Interim Technical Report

DIABLO CANYON UNIT 1
INDEPENDENT DESIGN VERIFICATION PROGRAM
-PUMPS-
ITR #32
REVISION 0

Docket No. 50-275
License No. DPR-76

Figure 4
 Mounting Plate Details -
 Auxiliary Saltwater Pump

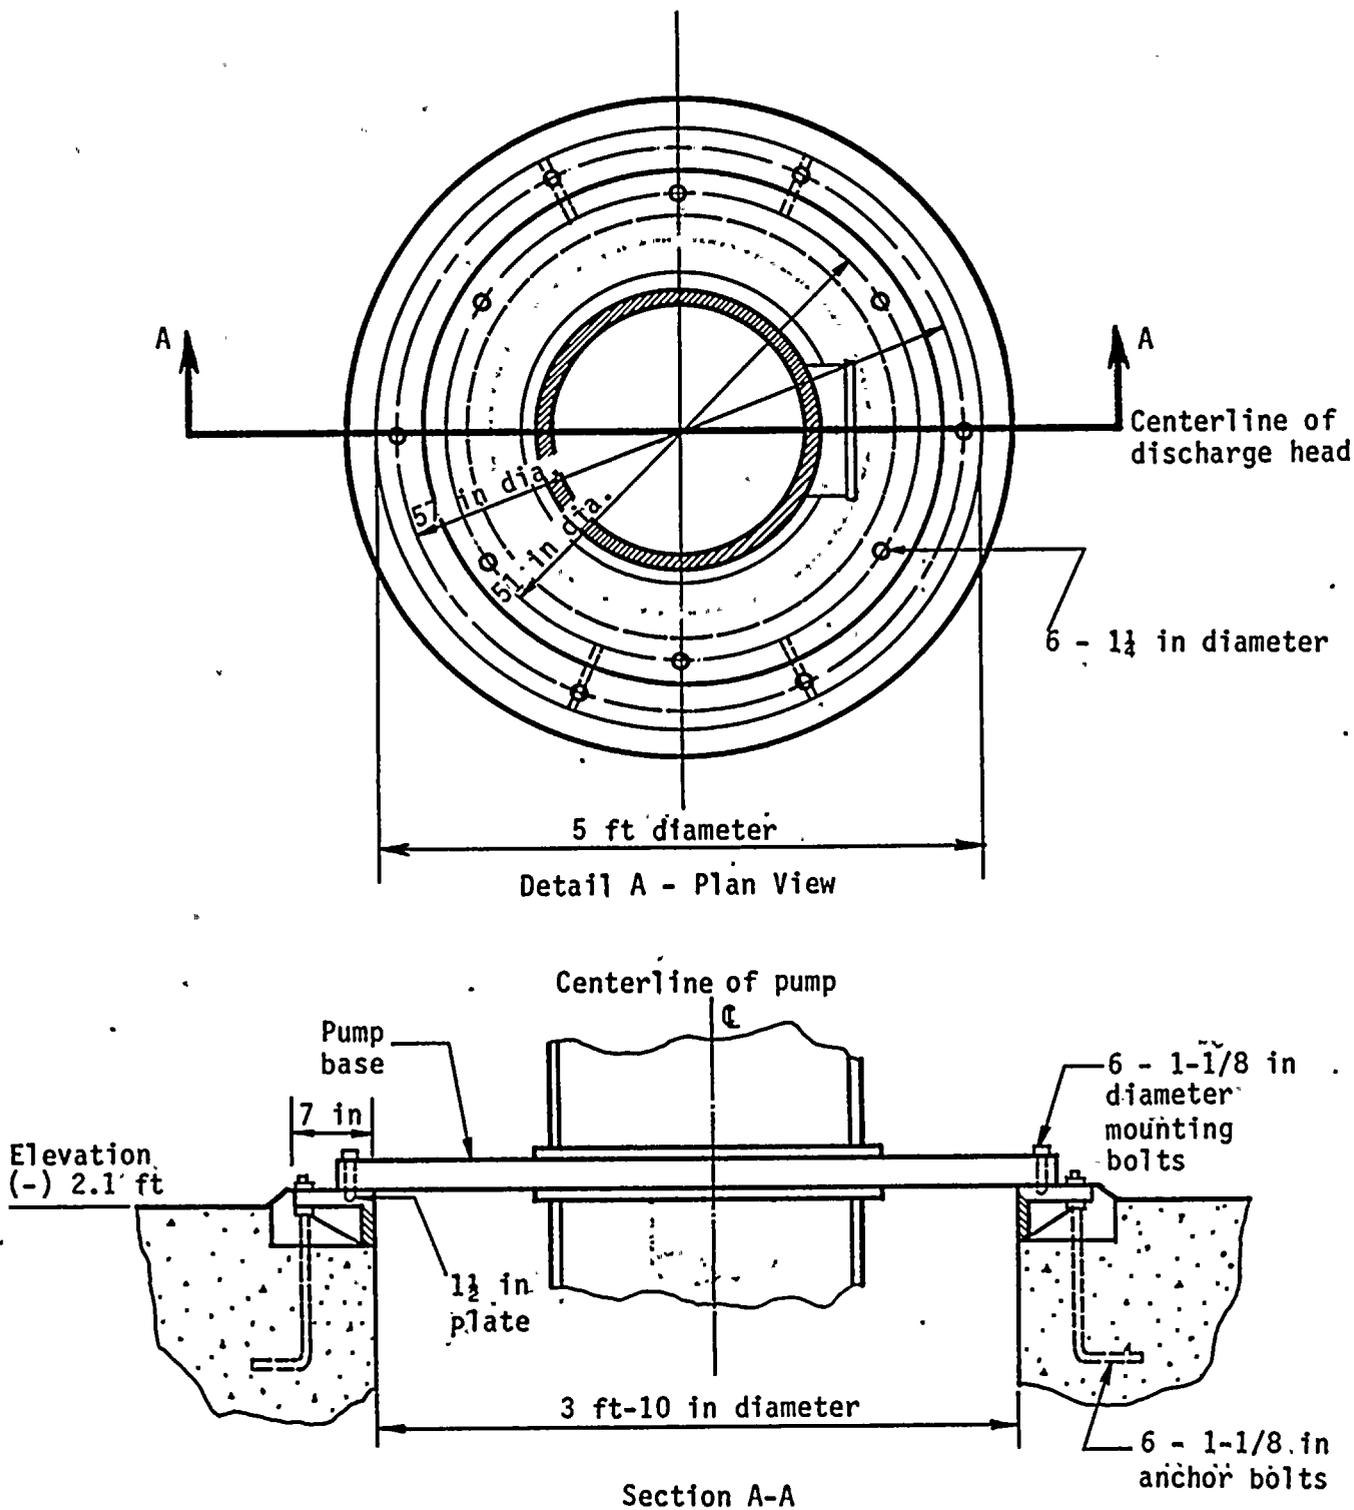
The verification analysis computed a lower bound vertical frequency which assumes the bolted mounting plate to have simply supported edges, while the design analysis assumed clamped edges.

The IDVP determined that the difference in horizontal frequency results was due to the incorrect application of the Rayleigh energy method in the design analysis (see Section 3.2.3). Differences in vertical natural frequency were due to different boundary conditions used by the analyses to model the mounting plate. The IDVP attributed the higher stresses in the verification analysis to the simply supported edge boundary condition assumed for the mounting plate.

Figure 6
Application of Rayleigh Energy Method-
Design Analysis

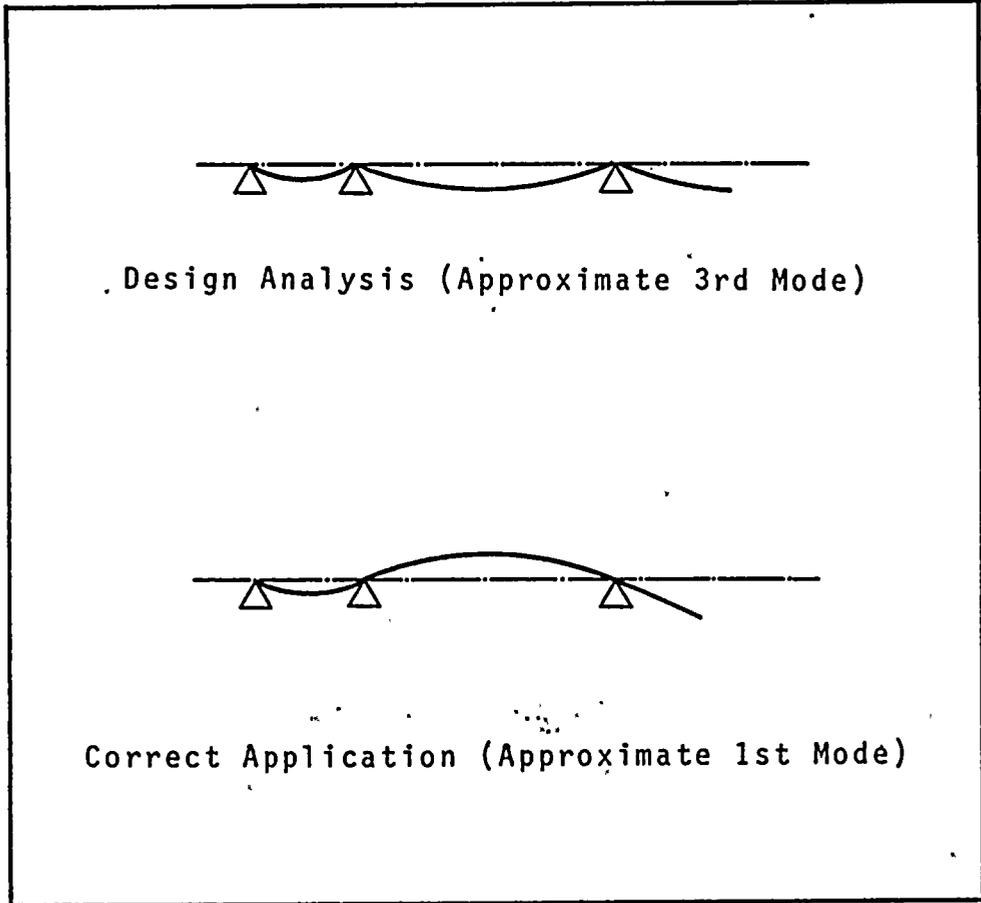
Using the Rayleigh energy method, the design analysis found the pump natural frequency to be greater than 33 hertz. A static analysis approach was then used, applying a seismic load at each respective component mass center of gravity. The IDVP determined that the assumed first mode shape in the design analysis actually approximates the third mode shape and thus, the design result for the horizontal natural frequency was incorrectly calculated. Figure 6 shows the application of the Rayleigh energy method in the design analysis.

The stress differences between the verification and design analyses were caused in part by PGandE's incorrect application of the Rayleigh energy frequency calculation method. (See Section 3.2.3). Approximate third mode shape displacements were assumed rather than the first mode shape displacements, which has a significant contribution to the overall dynamic response (see Figure 6). Different boundary conditions assumed by the analyses also contributed to differences in results. Because of the incorrect application of the Rayleigh energy method, EOI 1073 was classified as a Class C error.
